**Flambeau Mine: Water Contamination and Selective “Alternative Facts”**  
Robert E. Moran, Ph.D., May 2019 (posthumous), 116 pg.

## **Flambeau Mine: Water Contamination and Selective “Alternative Facts”<sup>1</sup>**

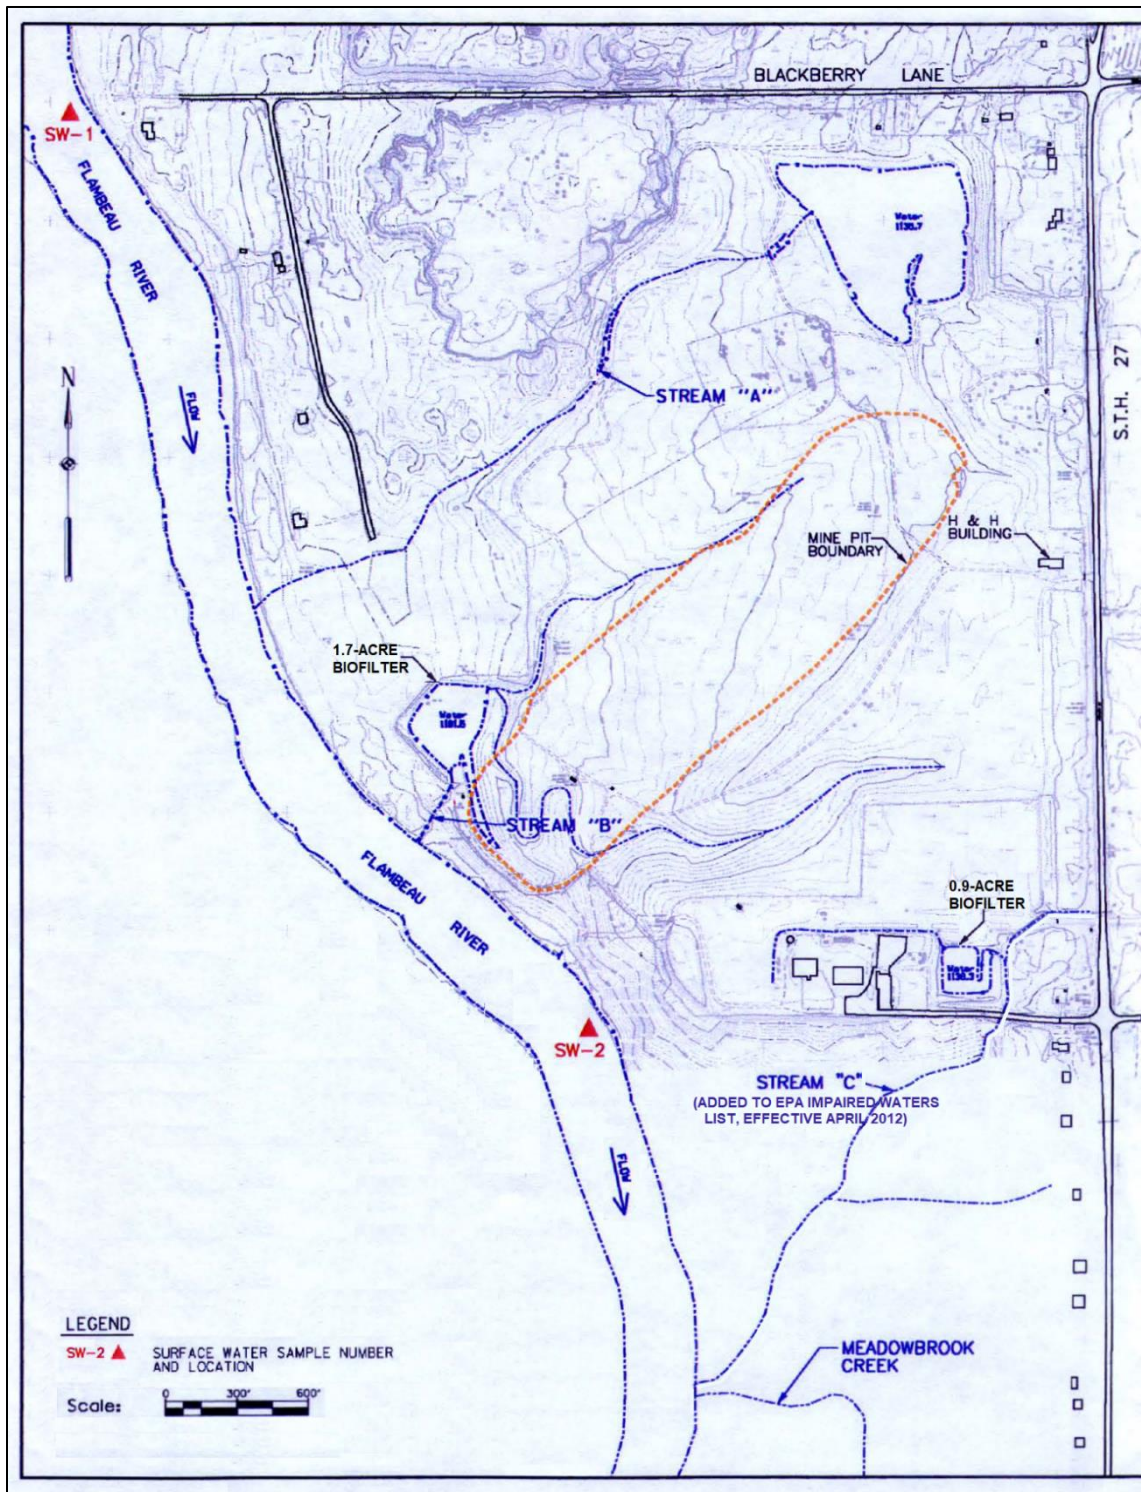
Another issue regarding FMC’s baseline surface water monitoring program involves sampling site locations. A comparison of diagrams from FMC’s 1989 EIR (Foth, 1989a) and 1991 Updated Monitoring Plan (Foth, 1991) shows that the locations of important, fundamental monitoring stations (e.g. the company’s upstream and downstream monitoring sites in the Flambeau River) were changed by FMC after baseline studies were completed, hampering determination of Flambeau Mine contributions. Most notably, the downstream sampling site currently used by the company (SW-2) is roughly 3 river-miles upstream of the original site used for baseline determinations. While now closer to the project site, SW-2 is still roughly 500 feet downstream of the backfilled pit and upstream of the discharge point of Stream C, a small Flambeau River tributary that crosses the FMC property and historically has been used as a conduit for conveying contaminated storm water runoff from the mine site to the Flambeau River (Chambers & Zamzow, 2009). FMC has established no river sampling stations adjacent to or immediately downstream of the backfilled pit. See Figure 1 – Flambeau River surface water sampling stations.

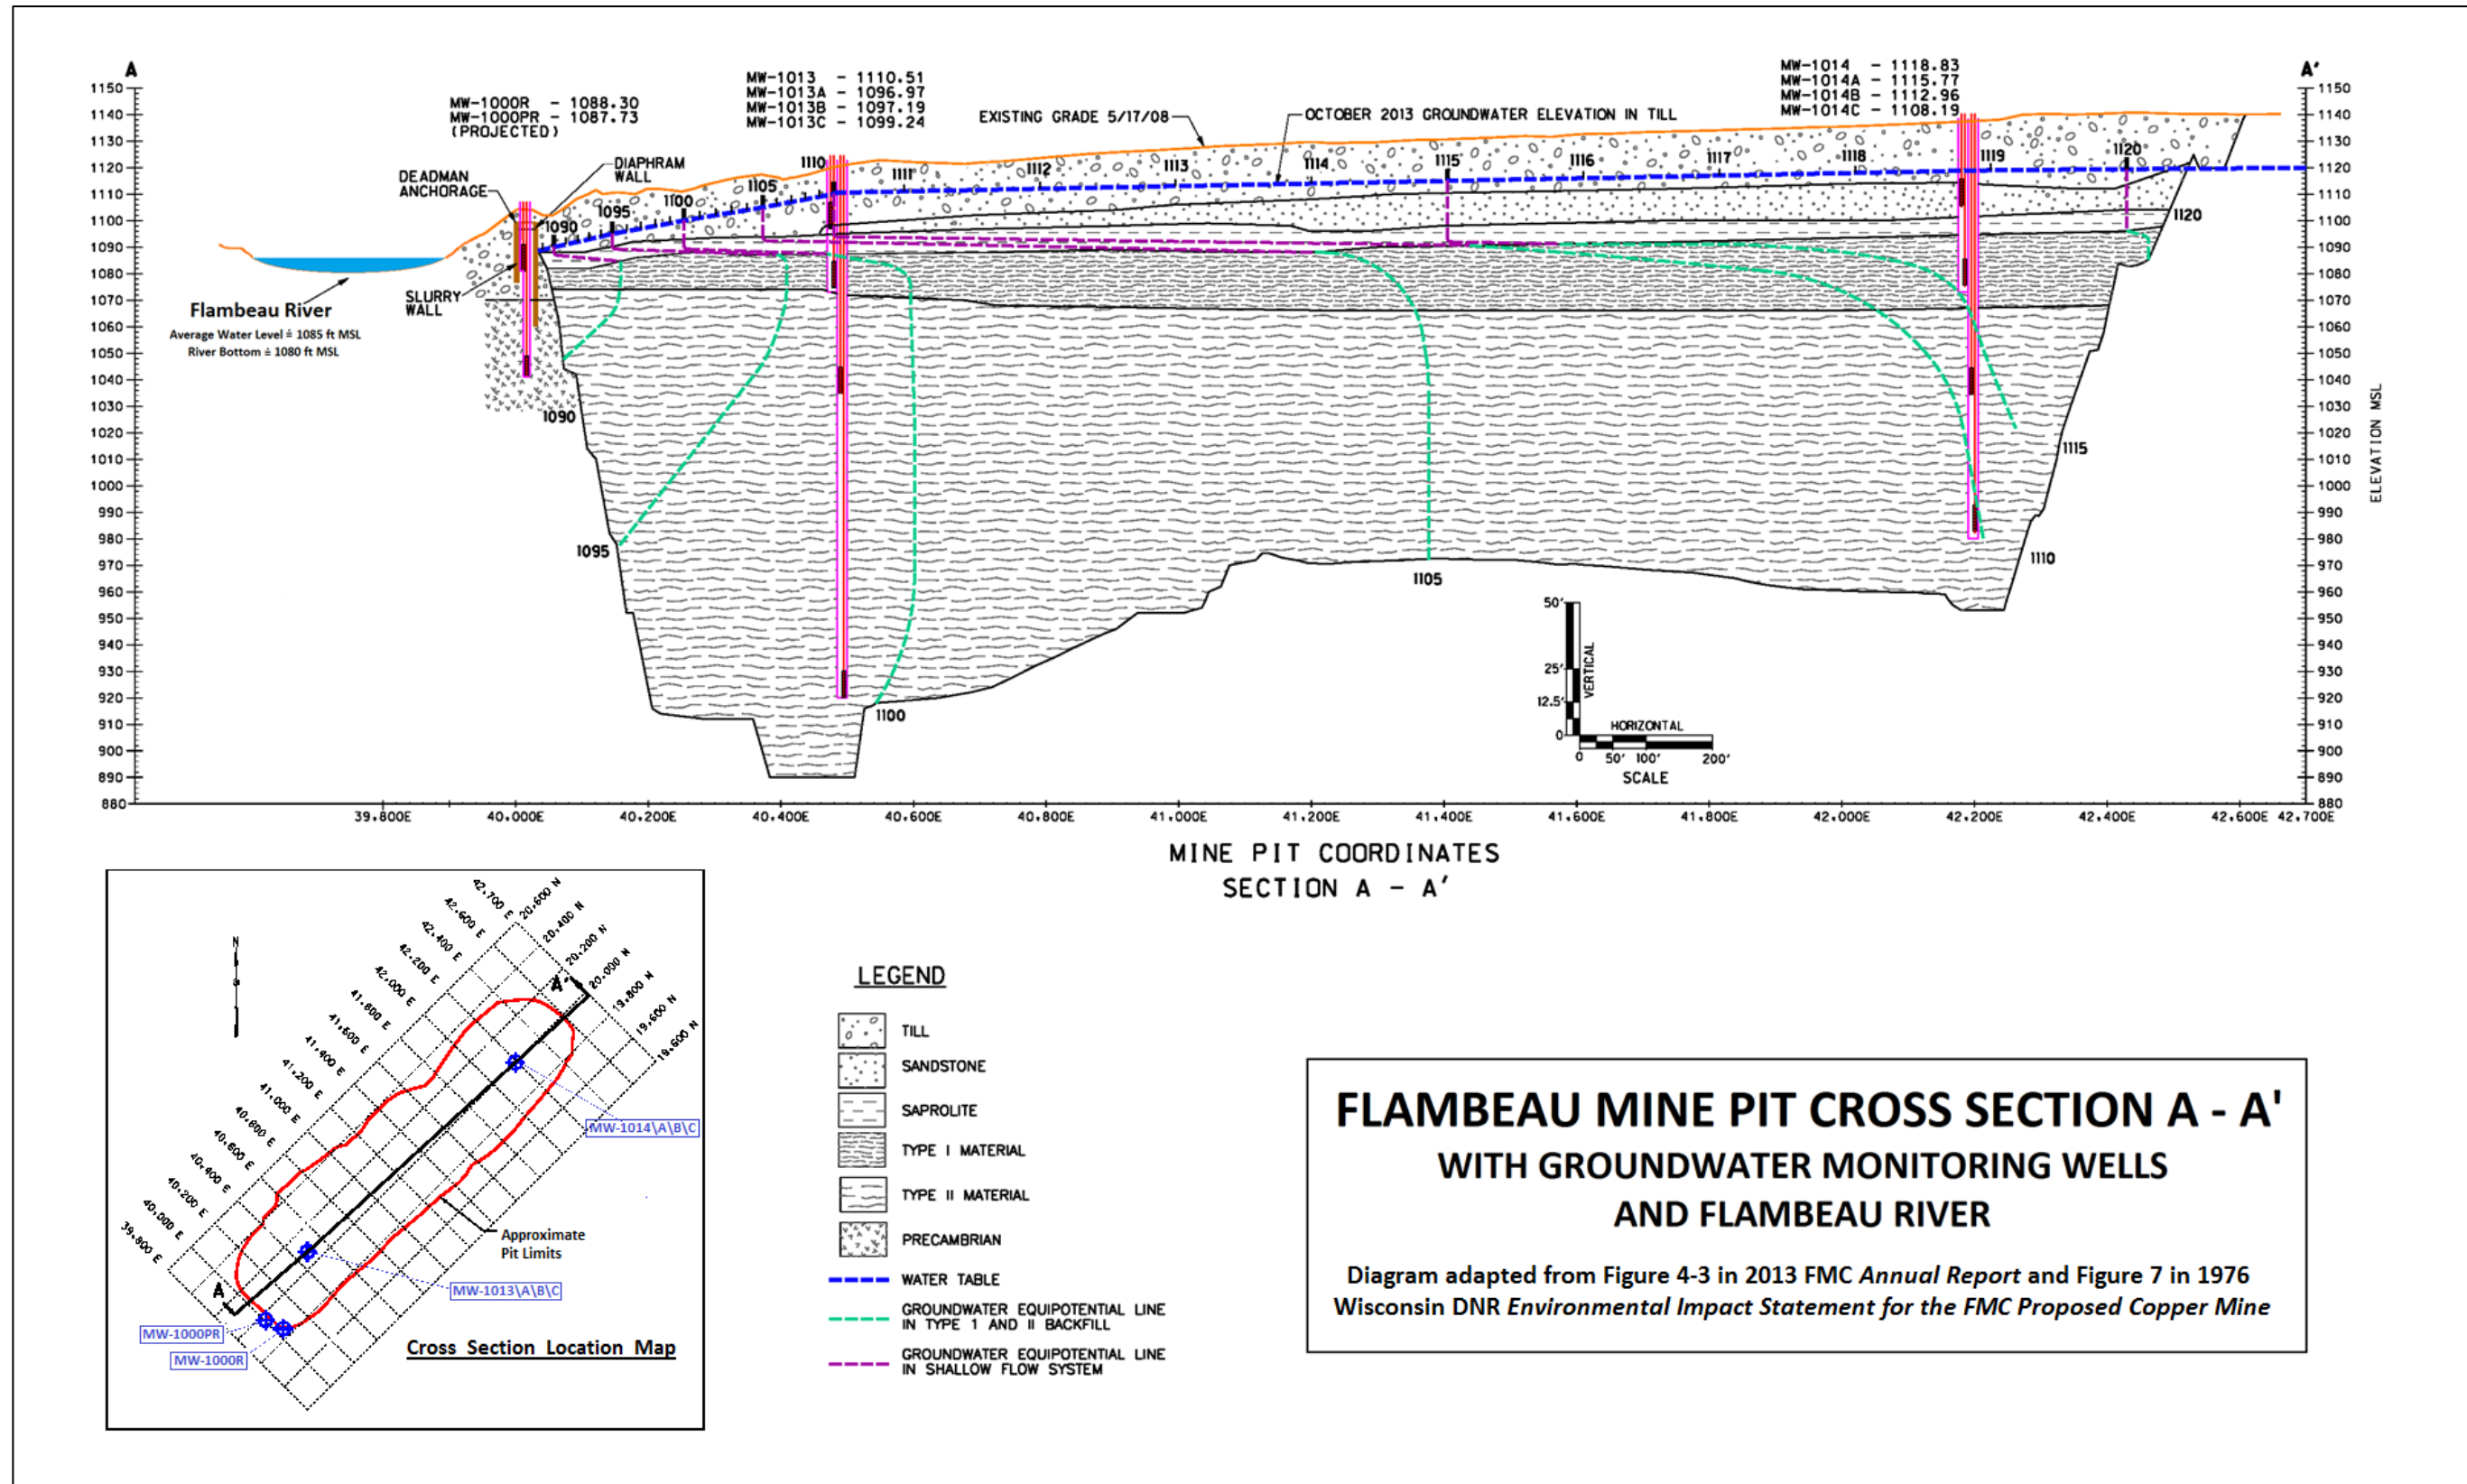
Despite all of the above, a major collapse involving multi-bench movement occurred along a section of Flambeau's north pit wall in March 1996. As reported by FMC in its 1996 Annual Report, the movement affected an area of the final wall from mine coordinates 40,500 east to 41,300 east and extended vertically from the 1,000' level of the mine to the crest of the pit at the 1,100' elevation. See Figure 6 – Backfilled pit cross section, for coordinate positions and elevations.

Contrary to the above statements from Foth, the physical relationships between the backfilled pit, the Flambeau River and the surrounding rock formations indicate that *most* of the contaminated pit water is likely migrating downgradient in the Precambrian bedrock via fractures and faults, and is not entering the river (see Figure 6 –Backfilled pit cross section).

**Figure 7.** State of Wisconsin-established compliance boundary for enforcement of ground water quality standards at Flambeau Mine plus current monitoring well (MW) locations (Adapted from Figure 1 *in*: Groundwater Monitoring Well Nest Installation at Compliance Boundary, FMC, 2000).

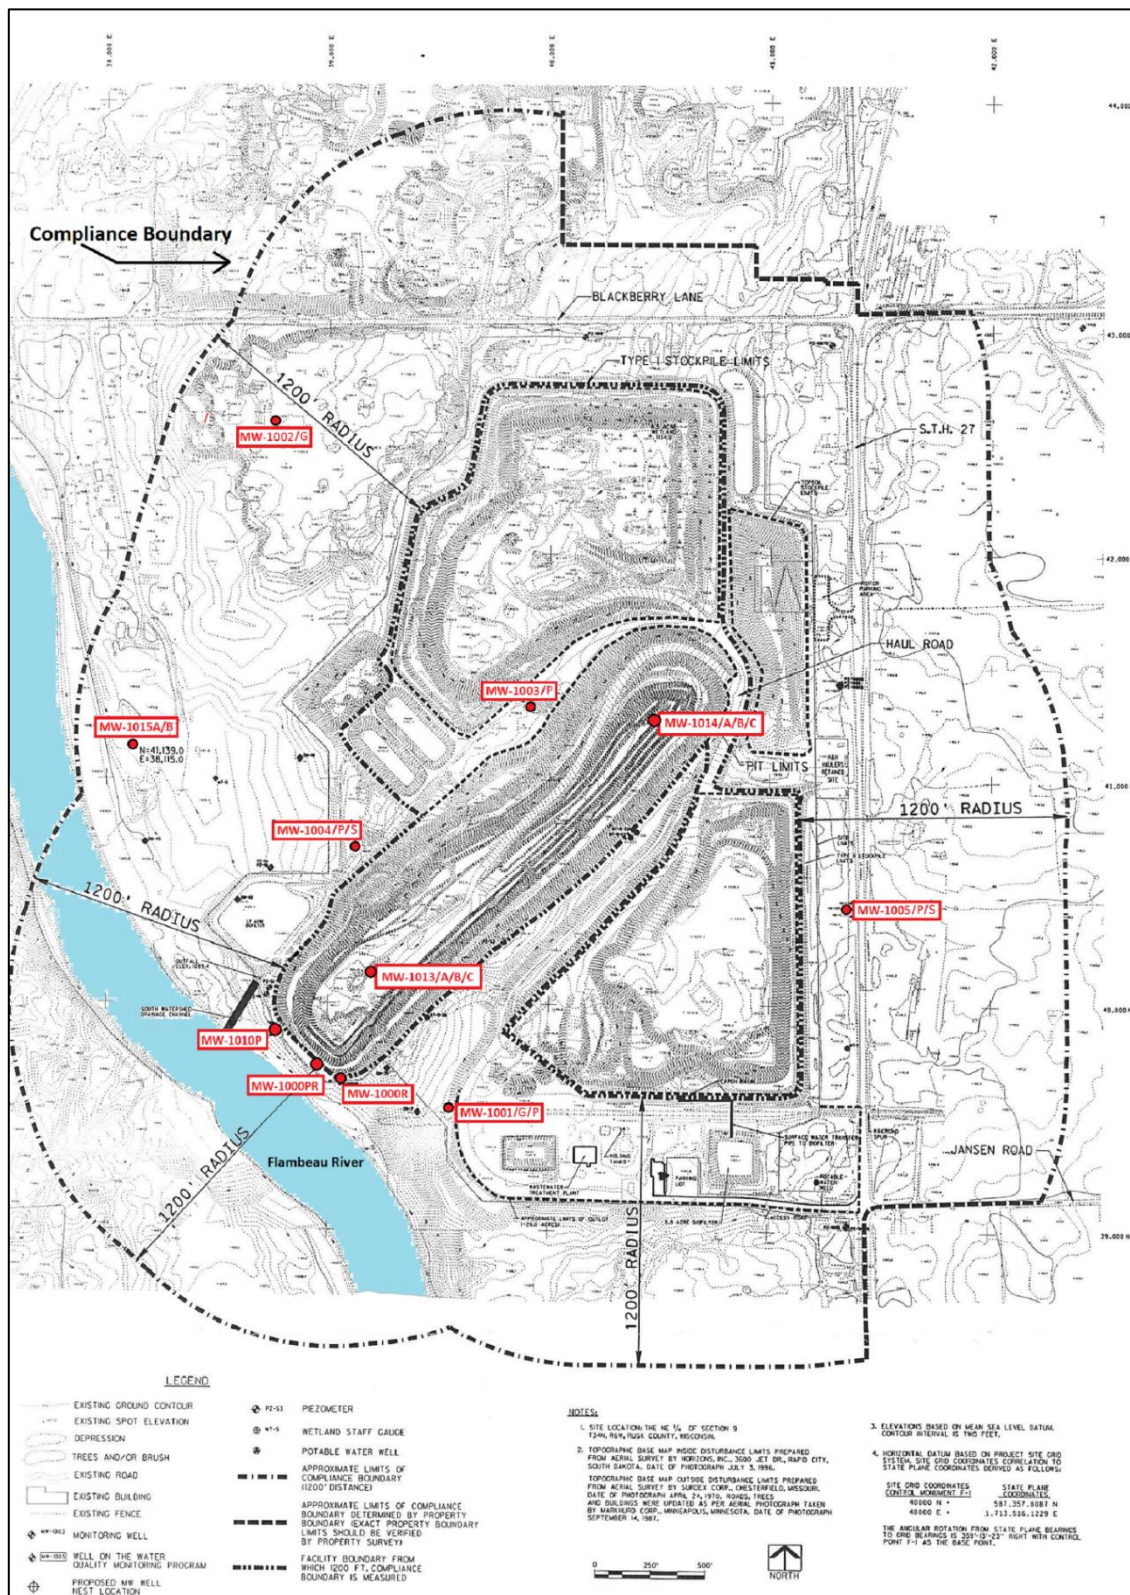
The FMC compliance boundary is about 3.5 miles long, encircles the entire mine site and crosses the Flambeau River southwest of the backfilled pit, disregarding possible impacts to the water quality of this river (see Figure 7 – Compliance boundary). This was a notable point of contention prior to the 1990 permit hearing, when the Office of Public Intervenor within the Wisconsin Department of Justice argued that the compliance boundary west of the pit should be the Flambeau River (Falk, 1989). The Office cited, among other things, that Foth itself had characterized the Flambeau River as “the most logical compliance boundary” in its Prediction of Groundwater Quality Downgradient of the Reclaimed Pit for the Kennecott Flambeau Project, dated July 1989. After the Public Intervenor made her argument, however, Foth released a revised version of the groundwater quality report, dated December 1989, that no longer included the above reference to the Flambeau River. The report also claimed that

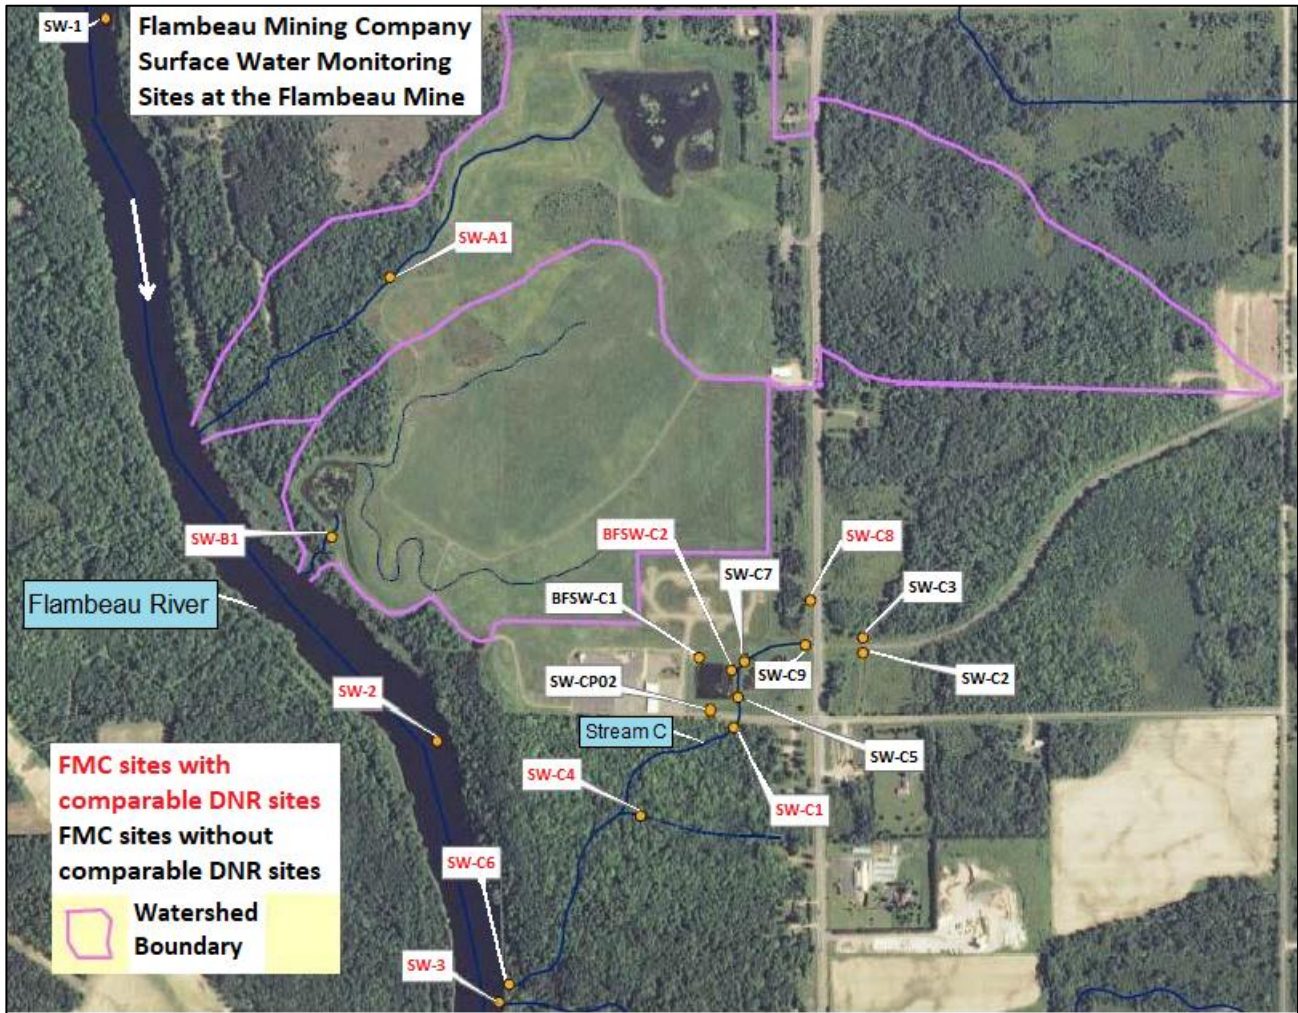
For a brief time (2007-2012), FMC was required to report limited water quality data from a Flambeau River sampling site (SW-3) immediately below the mouth of Stream C (WDHA, 2007; Foth, 2007; see Figure 10 – Flambeau Mine surface water sampling stations). As observed by Chambers and Zamzow (2009), the copper concentration at SW-3 was nearly double Wisconsin's hardness-adjusted chronic water quality criterion during the Spring 2008 sampling event, while the copper level at SW-2 was below the standard. Additional data would be helpful to determine trends.
